Model
Administrative Change Notice

1. Document Number:	ANL-EBS-MD-000027	2. Revision:	03	3. ACN:	03
4. Title:	Drift Degradation Analysis				
5. No. of Pages Attached	3

Figure 7-21. Numerical Experiment, Category 1: Failure Envelope

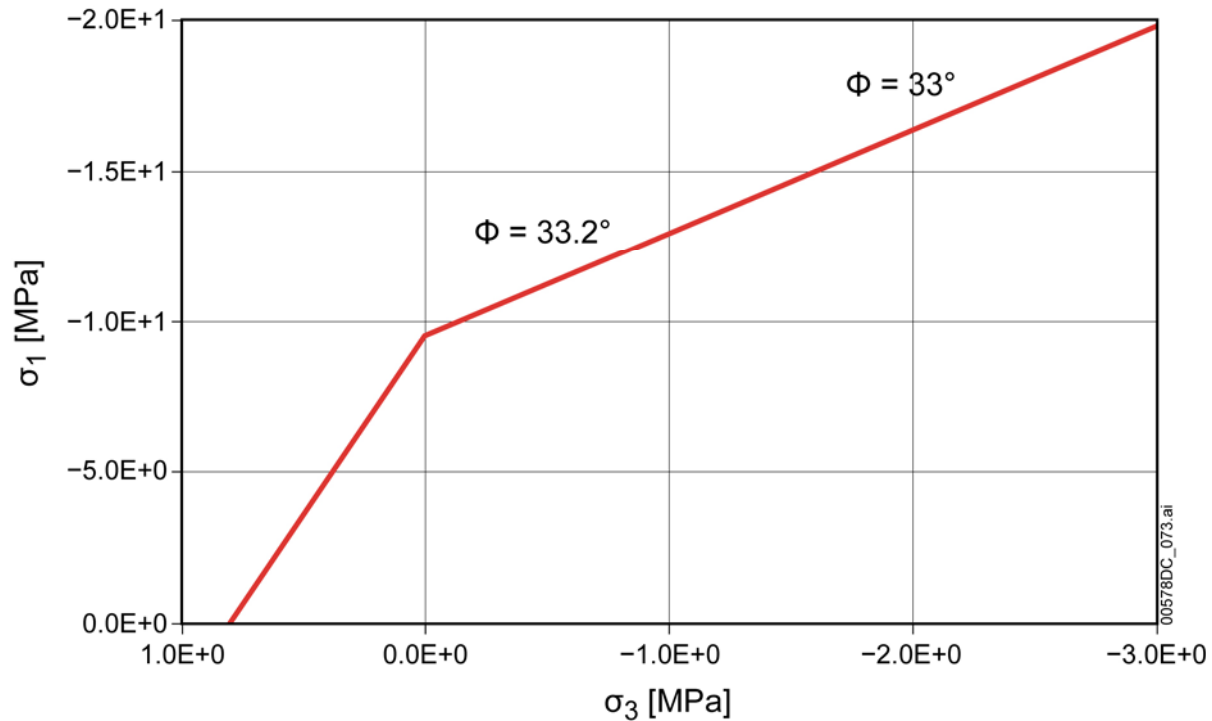
7-39	<p>Typographical error</p> <p>Figure 7-21 “Numerical Experiment, Category 1: Failure Envelope”, on page 7-39 has been replaced to correct typographical error on the legend of the figure.</p> <p>Note: This change to the figure has no impact on the results of the Drift Degradation Analysis report.</p> <p>This change was identified previously in ACN 02 and is associated with CR-5600.</p>				
9-18	<p>Citation update (Correct DIRS as appropriate)</p> <p>Reference 161949 on page 9-18, change:</p> <p>BSC 2002. <i>Software Code: UDEC. V3.1. PC WINDOWS 2000/NT 4.0. 10173-3.1-00.</i> 161949</p> <p>To</p> <p>BSC 2002. <i>Software Code: UDEC. V. 3.1 Sub-Release 3.10.109. WINDOWS 2000/NT 4.0. STN: 10173-3.1-00.</i> 161949</p> <p>DIRS reference has been updated by the TDMS staff</p>
